REPORT FOR CONSIDERATION AT PLANNING SUB-COMMITTEE

Reference No: HGY/2020/2794

Address: Land to the North of Ermine Road N15

Proposal: Temporary planning permission for a period of 7 years to provide 38 modular units for use as accommodation for people who have been street homeless, with associated cycle and refuse storage.

Block A Louver screening detail

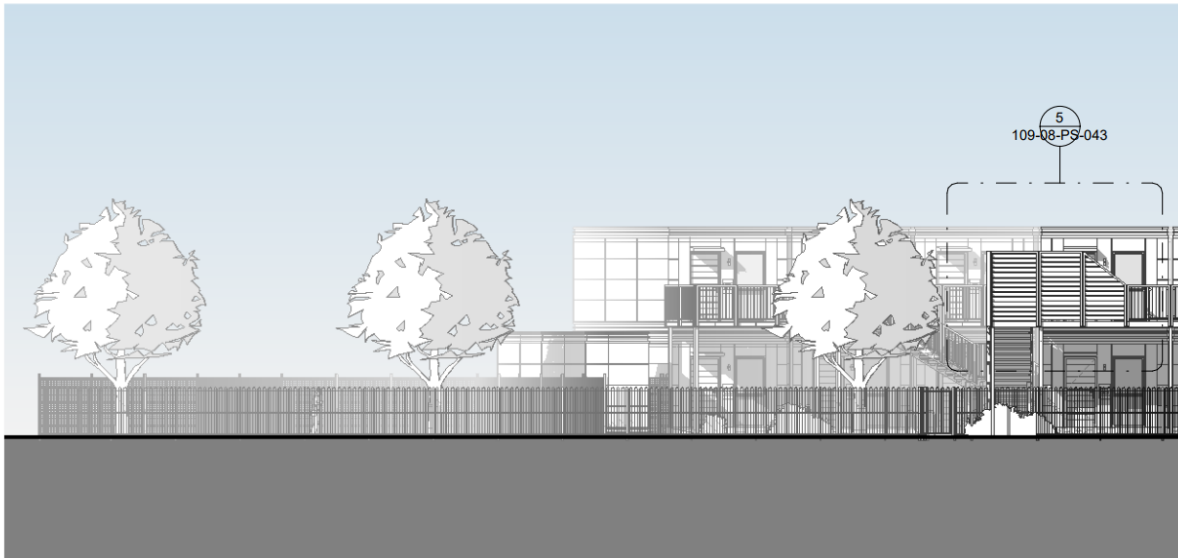
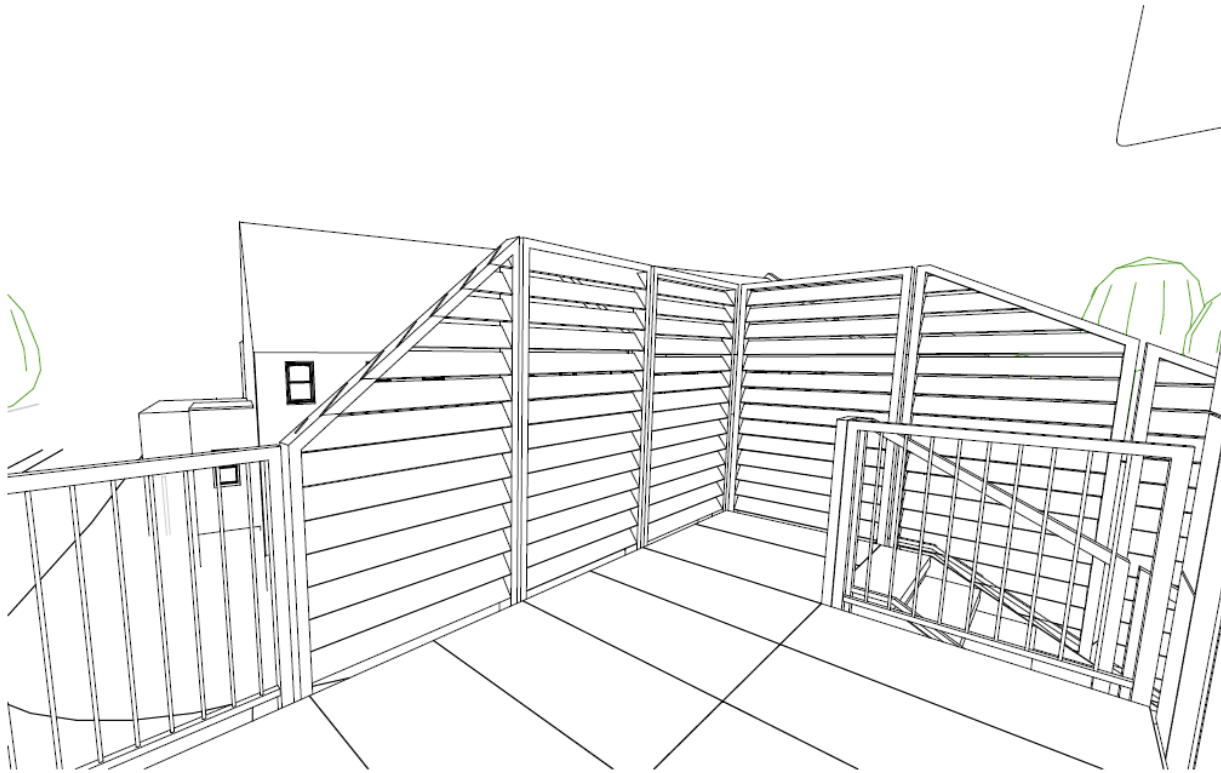
3.1.1. Concerns were raised by members of the committee at the meeting on 11 January 2021 in relation to the potential for overlooking from the stair and raised platform to Block A (which provides access to the upper storey of this block) towards existing dwellings on Ermine Road. Concerns were also raised about the colour of the front and rear elevations of the modular units which were proposed to be in orange.

- *The louvred screens would hide pedestrians nearing the top of the stairs and at those corners from the nearest existing houses and reduce their visibility from the street, whilst still allowing some visibility of them in the centre of the access balcony and still leaving the front doors and windows to those 1st floor flats visible from the street and with a view of the street at the T-junction, where there will be no close direct line of site from those flats or their balcony to existing residential neighbours.*
- *However, it is considered important for the visibility of the development, and to integrate the residents into the community, that the flats in Block A look out*

- 6.1.2 The louvred screening would prevent direct views from the upper storey of Block A towards number 56 Ermine Road and the closest terraced property to the southwest. The screening to the western elevation would wrap around the corner of the building which would be closest to number 56 and the other properties in the terrace.

- 6.1.3 The screening would minimise any overlooking of number 56 and the wider terrace. The screening would taper down to the east as it moves beyond the front door of the first unit. Beyond this point, Block A begins to angle away from number 56 and views of this property and the wider terrace become more oblique.

- 6.1.4 The distance between number 56 and the platform which would now be screened off is 10 – 11m. The screening would increase the window to window distance to approx. 15m. It would also reduce the perception of overlooking towards and from the development by screening off the stair access.

- **Incorporate louvred screens** to the upper part of both staircases and to the ends of the raised platform to Block A. These screens would restrict views southwards of properties on Ermine Road from the upper storey of Block A. This increases the closest, non-screened window to window distance to from approximately 13 metres to 15 metres between Block A and the nearest property at number 56 Ermine Road.
- **Grey painted finish to match the flank elevations. The front doors would remain orange.** This would significantly reduce the presence of orange in the development.

- 20) The louvred screening indicated on the approved plans shall be installed as shown on drawing number '109-08-PS-043 Rev. B' prior to occupation of Block A and retained for the lifetime of the development.
